**Marin Municipal Water District
Addendum to the Amendment of the Mt.
Tamalpais Watershed Road and Trail
Management Plan – Restoration of Azalea Hill
Initial Study/Mitigated Negative Declaration**

State Clearinghouse No. 2004082018

March 2025

Figure 1 Azalea Hill Restoration Project Location

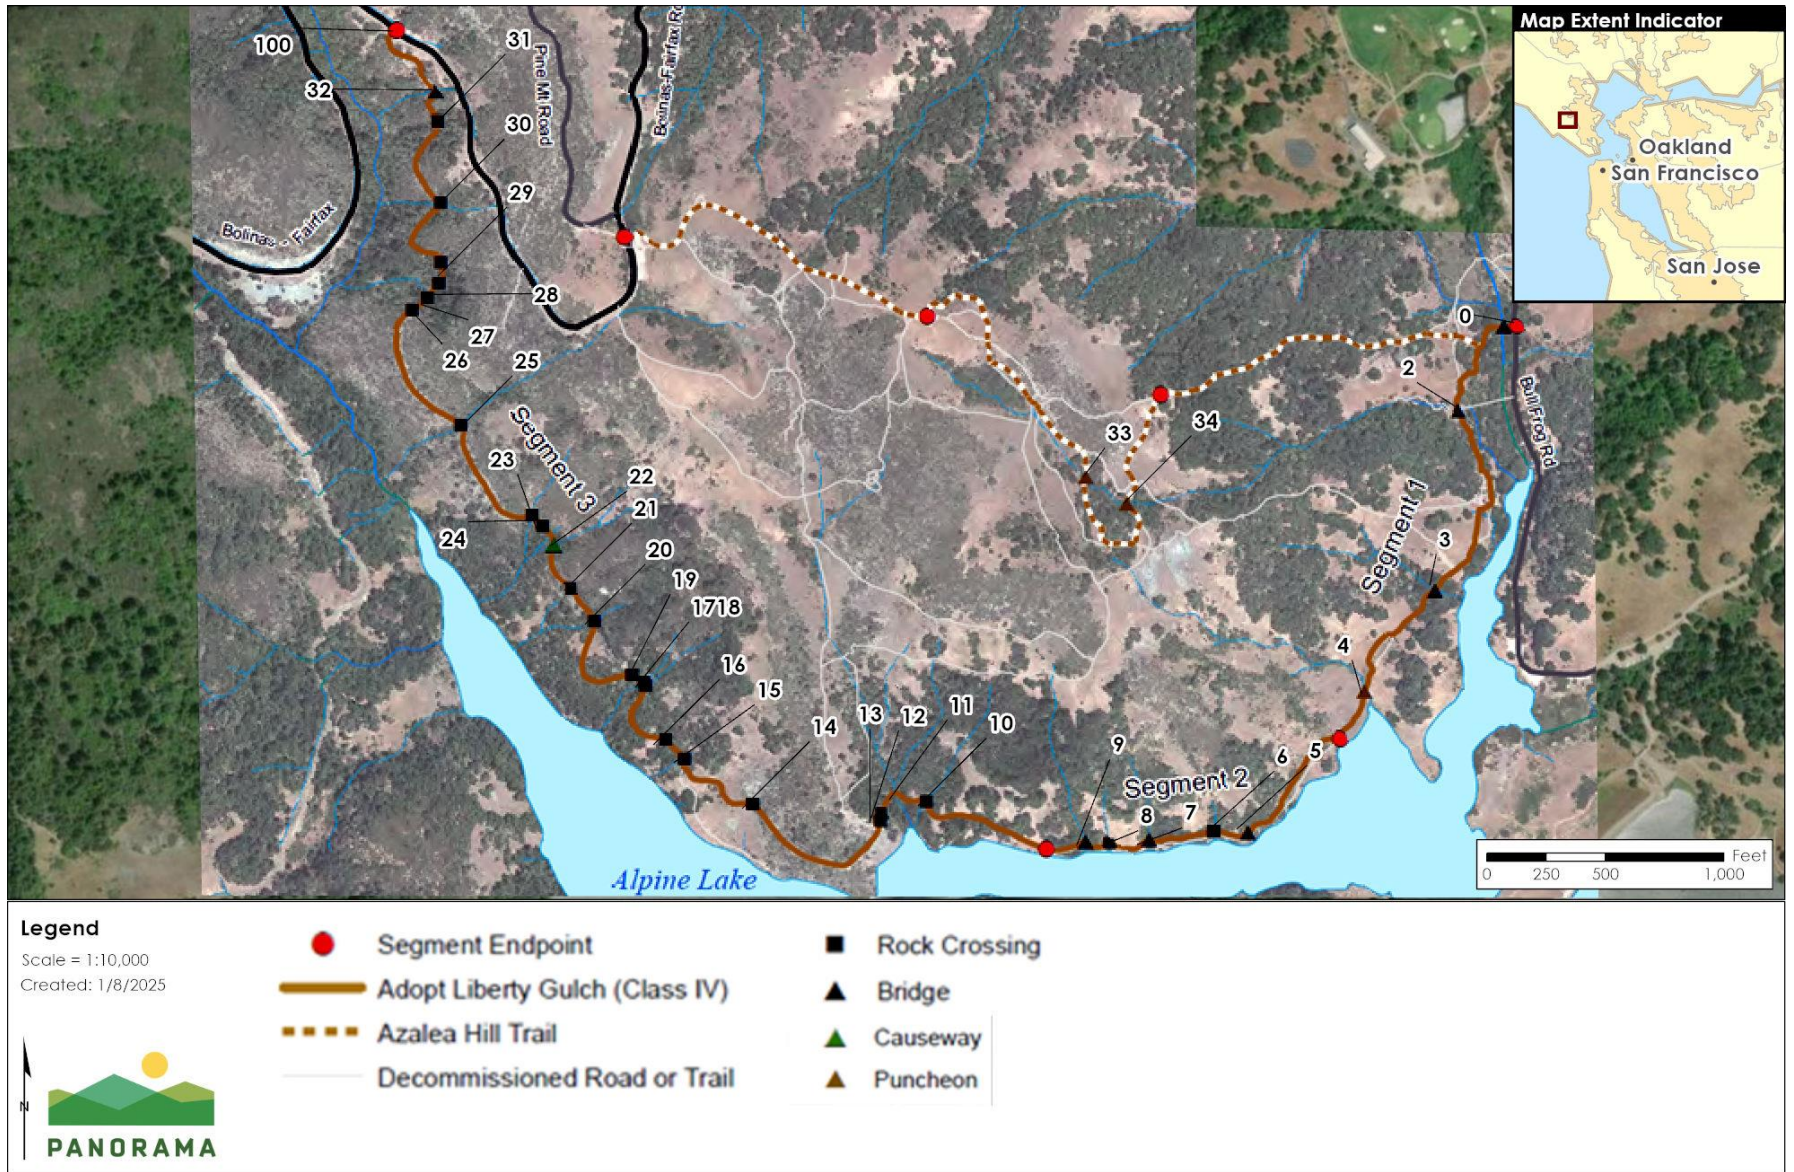
The Project is currently being implemented; however, an approximately 288-foot section of Liberty Gulch Road (within Segment 2, as shown in Figure 1) planned to be improved to a Class IV road through widening from approximately 18 to 24 inches to 4 feet is flanked by extensive populations of rare plants. While the approved Project allows for widening the trail and mitigating the effects to these rare plant populations, the District staff have found that the least impactful method in this area is to leave the trail at its current width and not actively disturb the rare plant populations. Additionally, improvements to Liberty Gulch Road under the Project included stream crossing upgrades at 34 sites. Six of these sites no longer need upgrades or upgrades can be minimized while still protecting water quality and reducing erosion from the road and trail improvements.

A 288-foot section of the Liberty Gulch Road segment, from stream crossing site 7 to 9 (shown in Figure 1), is surrounded by numerous rare plants, including extensive Mt. Tamalpais lessengia and Tiburon buckwheat. This section of trail is narrow (from 18 to 24 inches in width), and sloped, with little room to expand the trail and with rare plants flanking the existing trail. The Azalea Hill Restoration project's IS/MND includes Mitigation Measure 3.2-B.2 that requires avoidance of rare plants, and if avoidance is not practicable, development of a rare plant mitigation and monitoring plan. Per the measure, "The rare plant mitigation and monitoring plan shall maintain pre-project rare plant populations by replacing all affected rare plants via seeding or transplanting (relocating). The success criteria for seeded and relocated plants shall be full replacement at a 1:1 ratio [number of plants established = number of plants impacted] after five years, accounting for annual variability as measured by reference populations near the project area or in similar environmental (soil, aspect, elevation, etc.) conditions."

Page 2.23, Figure 2.05 – Oat Hill Map

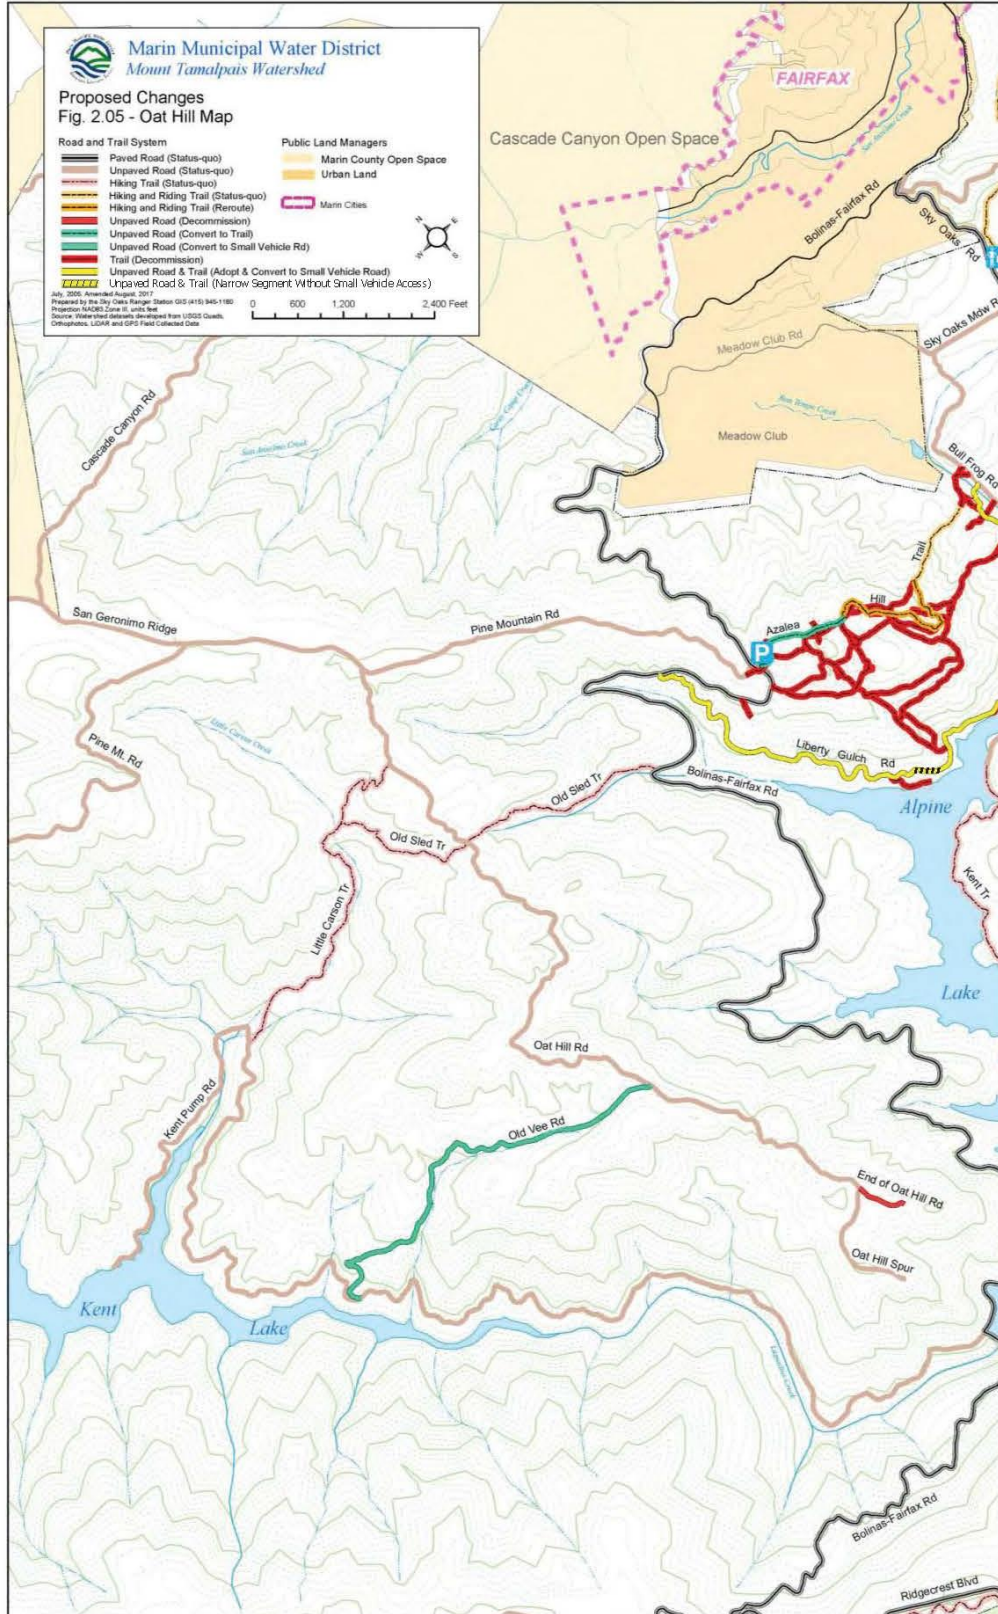
The Azalea Hill Restoration project included amendments to Chapter 2 of the 2005 RTMP. Minor changes to the amendments are proposed under the revised Project. This section identifies the chapter and paragraph of the proposed additional changes. The associated additions are shown in underline text.

*288Liberty Gulch Road is classified as Class IV, including the narrower 288-foot segment of road, allowing for multiple recreational uses (i.e., bicycling, hiking, and equestrian), but with modifications to the use through the narrowed road width along this segment. No patrol trucks or ATVs are allowed on this 288-foot section of road.

Figure 3 Locations of Stream Crossing Improvement Changes for the Revised Project

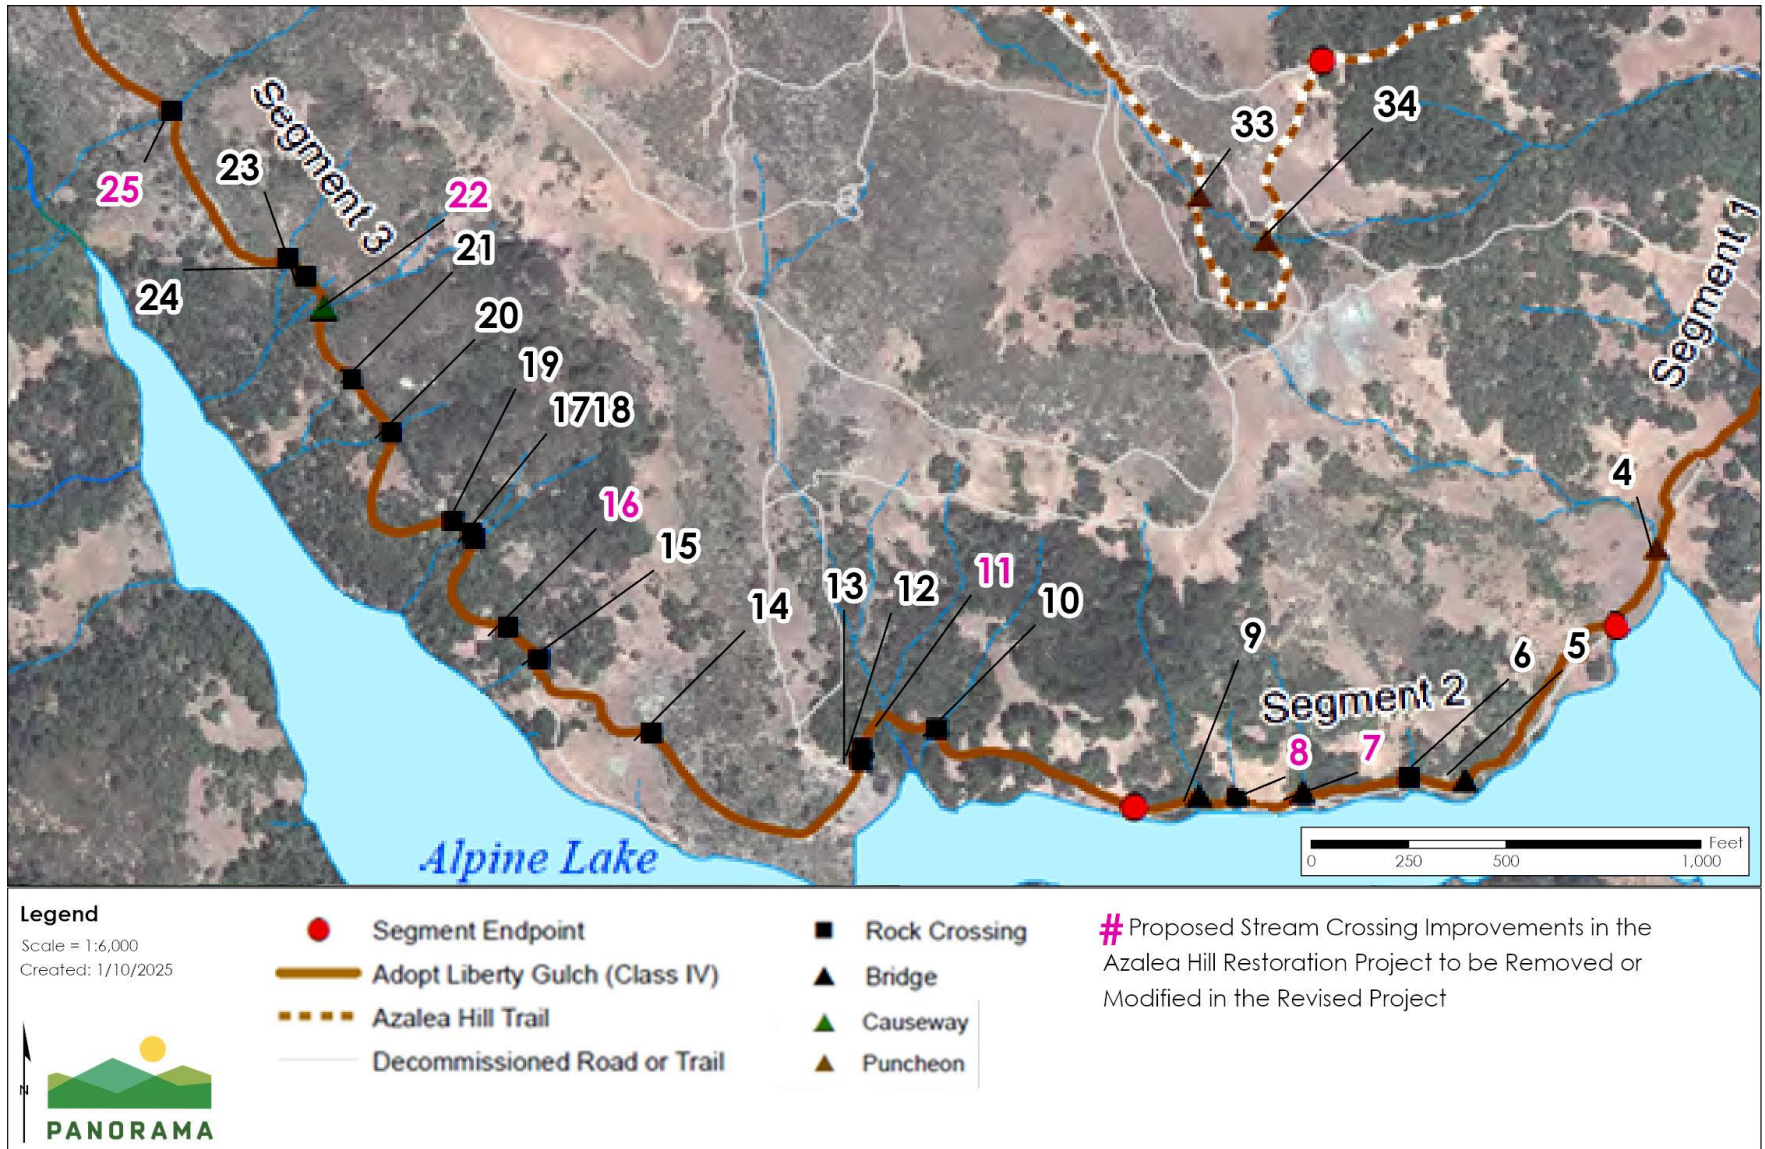
The Azalea Hill Restoration project included 34 stream crossing improvements. Six of these crossing improvements were determined not needed or need less work after field evaluation, which is in line with the District's stated approach in the Project of being "light on the land" in order to minimize effects to other sensitive resources, including rare plants. The crossings that are removed or modified as part of the revised Project are summarized below and shown in

Figure 3. Each of the modifications or removals were assessed by the District to ensure that the changes would still provide adequate erosion and sedimentation control.

Site	Crossing Type	Initially Proposed Action	Reason for Removal or Modification of Action
7	Bridge	Construct a 20-foot bridge above creek	No bridge construction due to presence of rare plants but some armoring to be installed avoiding the plants and to provide adequate water quality protection. This crossing is within the section of Liberty Gulch Road to be left at current conditions and width.
8	Armor	Construct an armored wet crossing with 6 to 12-inch rock	To retain existing hydrologic function as well as water quality, while avoiding impacts to rare plants precisely hand-place two to three 12" rocks into the stream crossing.
11	Culvert	Slip-line culvert and add trash rack	The culvert is functioning and clean, therefore, no work is needed.
16	Armor	Construct armored wet crossing (5 cubic yards of 1-foot to 2-foot rock), treat approach, pull culvert	The culvert is functioning and clean, therefore, no work is needed.

22	Causeway	Raised boardwalk setback from fill slope edge (50 feet long x 4 feet wide).	No associated road widening is needed in this section of road; therefore, the causeway is not needed to keep users out of the stream. Rolling dips and drainage outlets would be added to adequately protect water quality.
25	Armor	Armored crossing, 50 cubic yards rock over 450 square feet (1-foot to 2-foot ft rock). Pull unstable fill, remove culvert. Treat 400 feet of approach	Leave culvert in place and armor instead of pulling culvert to avoid impacts to rare plants, while maintaining hydrology.
